Site Plan Review

(3210 Glynn Avenue)

Planning & Appeals Commission

December 13, 2023

SITE PLAN FOR ISLAND VIEW
RESIDENTIAL AND COMMERCIAL DEVELOPMENT
CITY OF BRUNSWICK, GEORGIA
PREPARED FOR:
MARITIME HOMES, LLC.

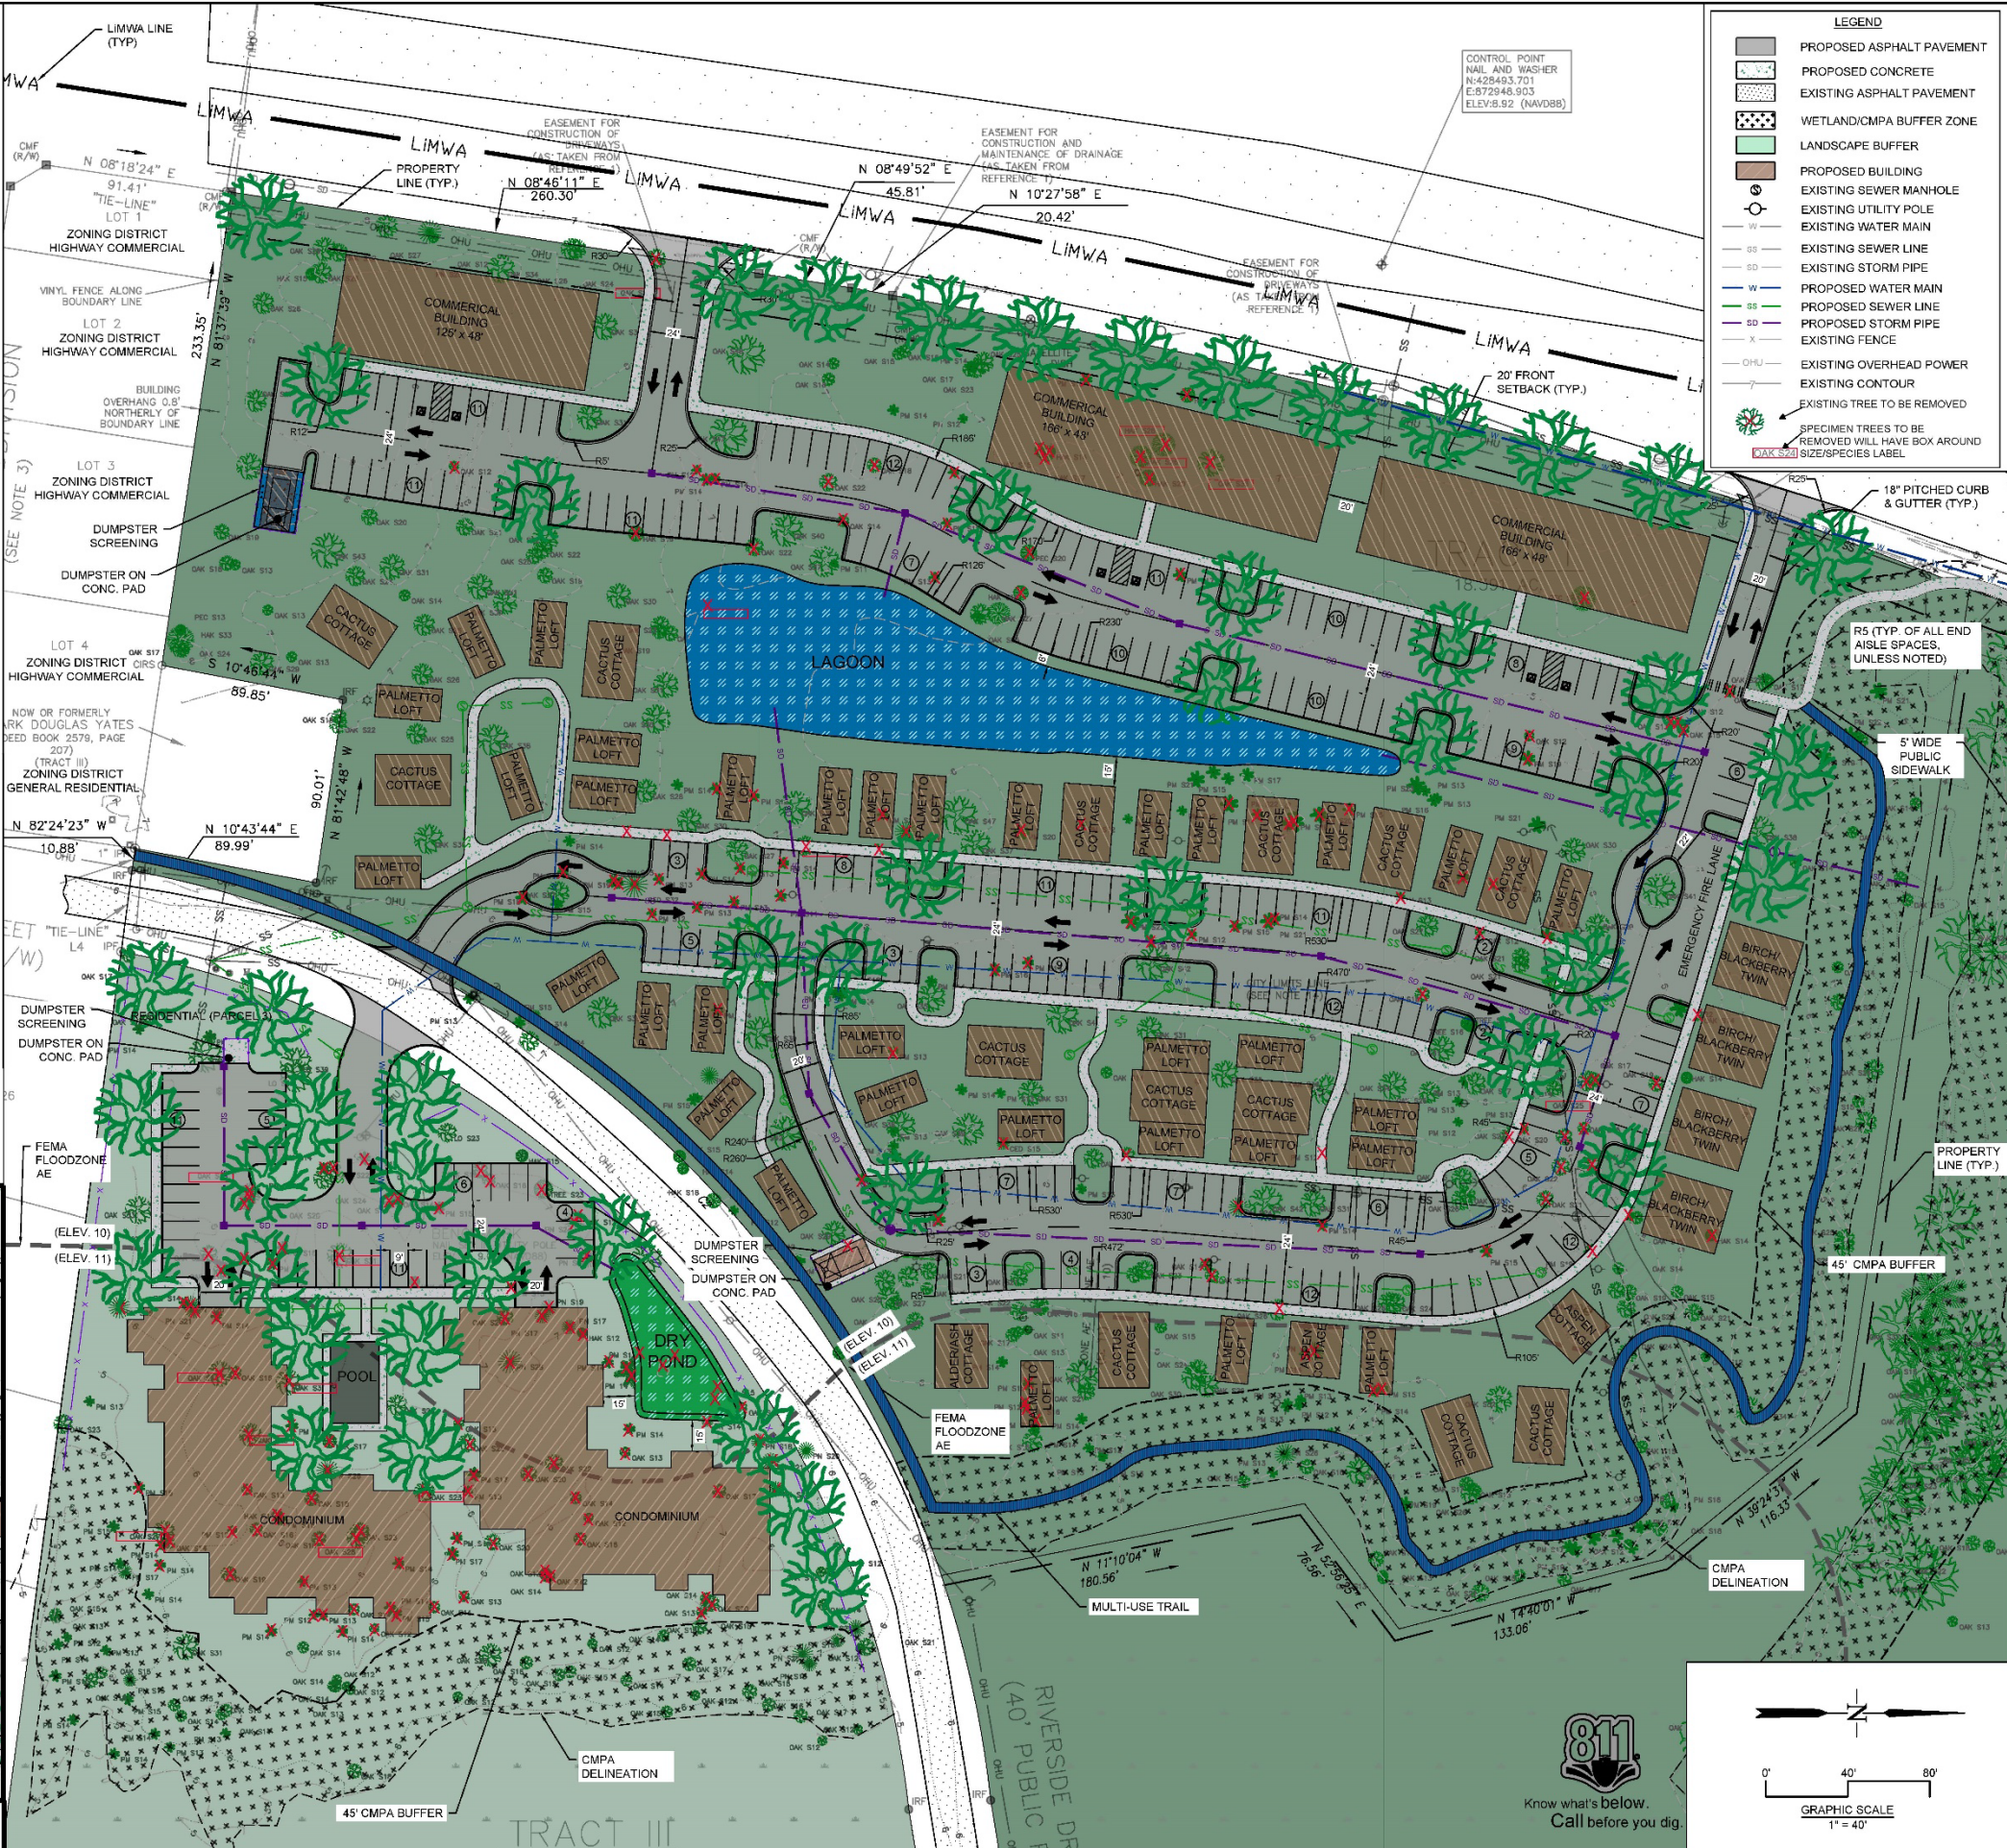
6) Sanitation: Dumpster/Compactor locations provided. **ADDED AT CONDO LOCATION IN 12/3 REVISIONS.**

7) Fire Access: Fire Marshal has reviewed and believes the current plan provides adequate access for equipment, other than the "tree split" at the northern. Suggested relocating planned planted tree, widening the northern arm and converting the adjacent parking to a Fire Access Lane. **ADDRESSED IN 12/3 REVISIONS**

9) Norman Street/Riverside Dr ROW Access: The developer has suggested that a roundabout be installed to address access and traffic control. City Engineering and Public Works has no issue with this solution. **REMOVED FROM PLAN IN 12/3 REVISION.**

3) 45' Marsh Buffer: Is reflected in the plan. Only amenity provided within the setback is a pedestrian path. This meets the requirements of the GADF.
